Ground Floor Flat, 15 Lyncroft Gardens
London, NW6 1LB

Basement Impact Assessment
Audit

London Borough of Camden

Project Number: 13398-11

Lead Local Flood Authority comments

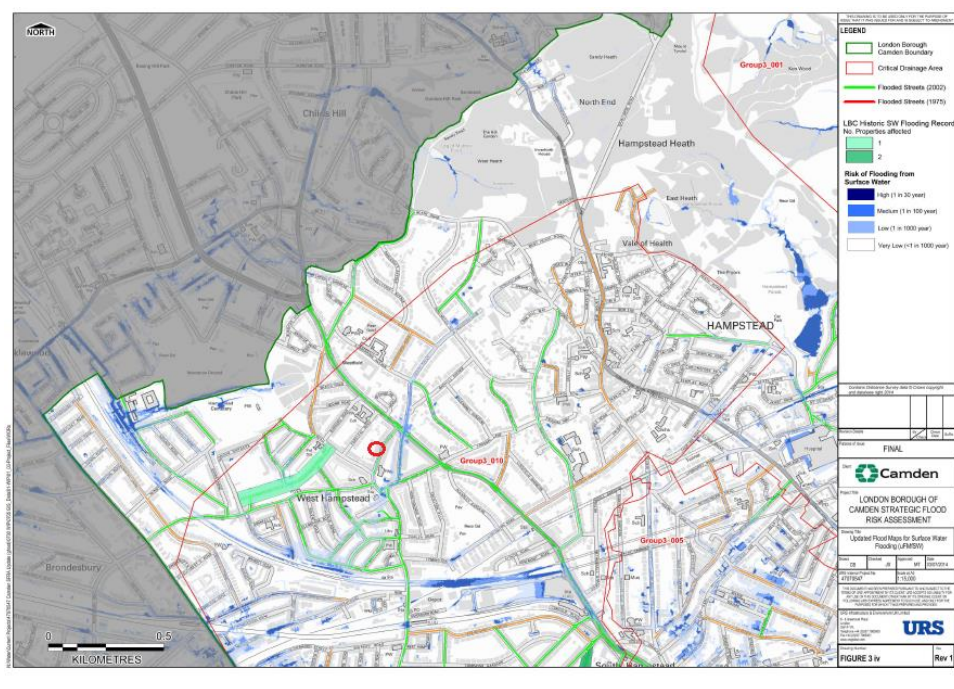
This site falls within Cannon Hill LFRZ, one of our Local Flood Risk Zones as defined in figure 6 of the SFRA (below).

Client: Advantage Basement & Cellar Company Ltd
Project: 15 Lyncroft Gardens
Title : Movement monitoring layout

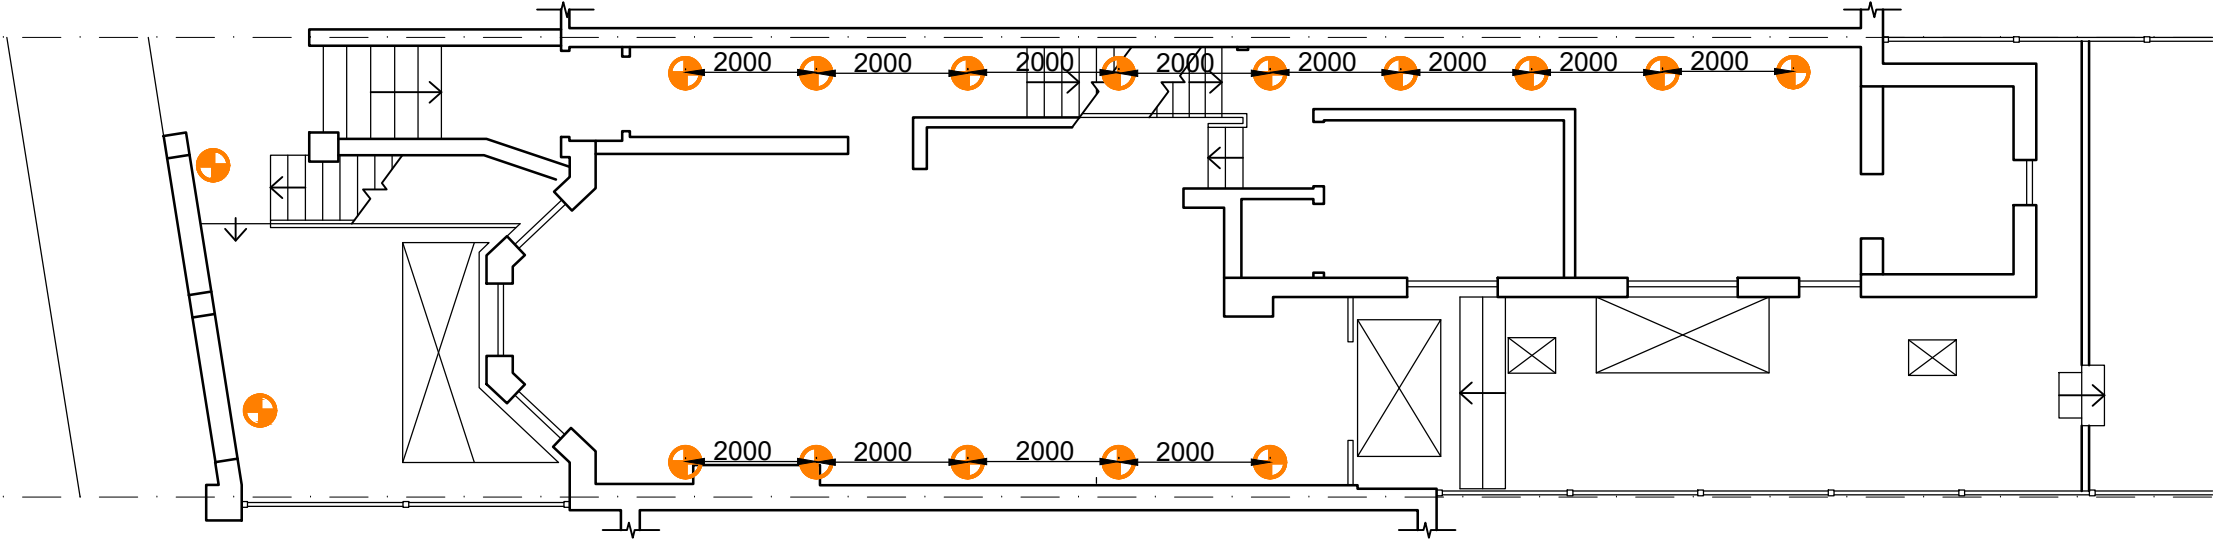
Could you/Croft please close out our monitoring query too in order to be able to complete our final audit report the following days? An update of the movement monitoring layout drawing presented in Appendix F of Croft's report would suffice at this stage. Could you please forward it at your earliest convenience?

- In the submitted BIA v.3 (Sections 10.2.3 and 10.2.4) it is stated that the assumed vertical and horizontal ground movements due to underpin installation will be 3.5 and 4 times the wall height respectively. Could you justify this assumption? Typically for other types of wall (contiguous, secant, diaphragm etc) and from experience, ground movements are anticipated to become negligible at a distance of 1.5 to 2 times the wall depth. Hence, the assumption made in the BIA is not conservative and may lead to a damage Category higher than 1, as previously noted in our query no 11. If I recall well, in another recent BIA job that you did for a site at Dunollie Road, you assumed that underpin installation movements reduced to zero at 1.5 times the wall depth and that was acceptable.
- Also, query no 6 (regarding monitoring of the adjacent pavement/highway) is still pending.

Please see drawing attached with monitoring positions shown on the front boundary wall.

1	29/07/2020	Front garden positions added
-	27/11/2019	First issue for comment
Rev	Date	Amendments
